TB20111205

Subject: New sight glass with float**Description:**

Photographs of new sight glass:**Photographs of original sight glass:****Phase-in schedule**

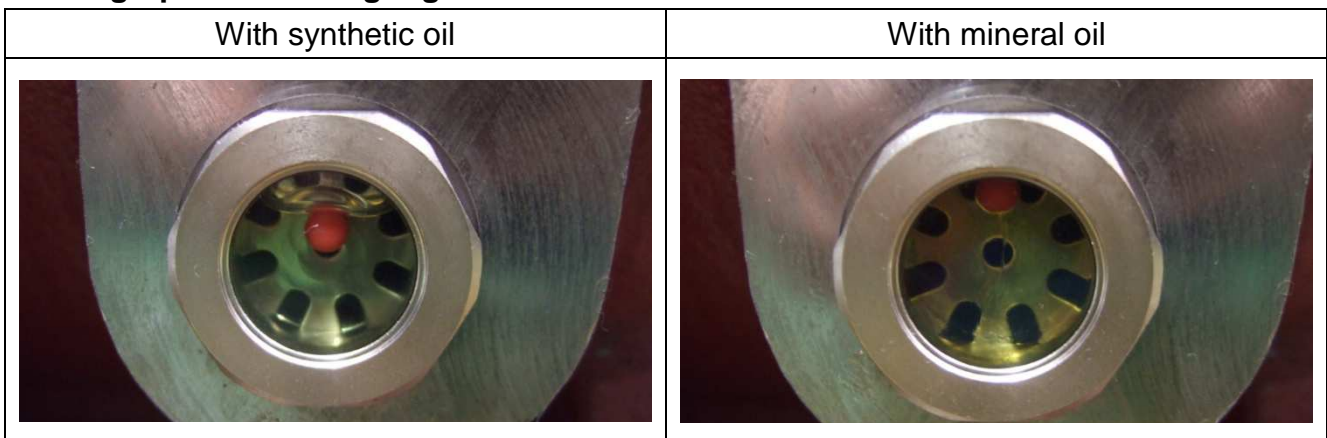
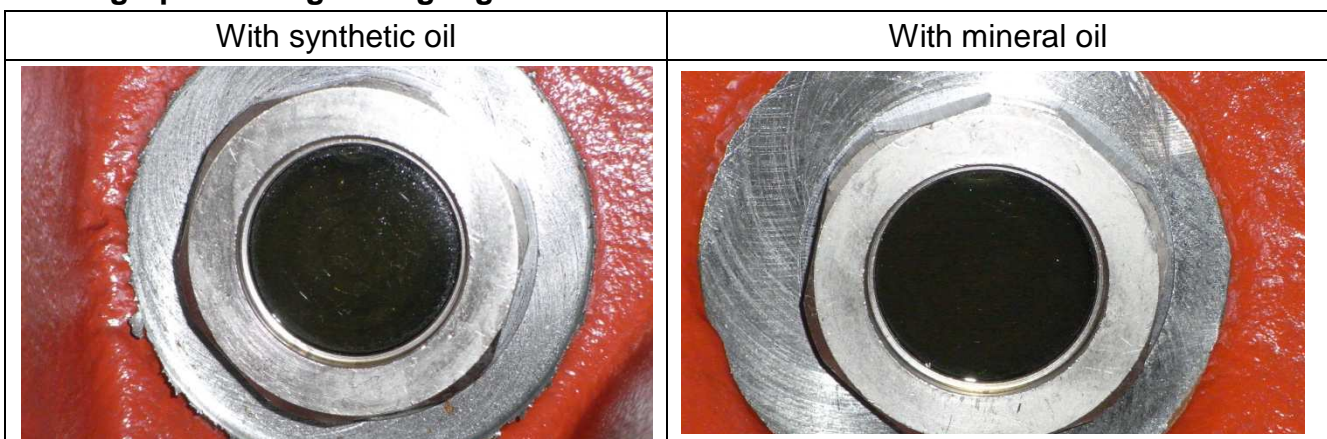
According to customer feedbacks, when certain refrigerant oils are applied, it is not easy to observe the oil level through current sight glasses. To avoid this problem and make observation more convenient, we hereby announce we will apply new sight glass with float. The features of new sight glass are:

1. There is a float in the sight glass and in the back of sight glass is a damper shield. The float will always be in the space between surface glass and the damper shield.
2. When there is oil inside of the compressor, the float will always be on the surface of oil level and help observe oil level.

The new sight glass will be used from 2012. Our sales representative will inform you when starting using it in your PO. Please don't hesitate to let us know if you have any questions.
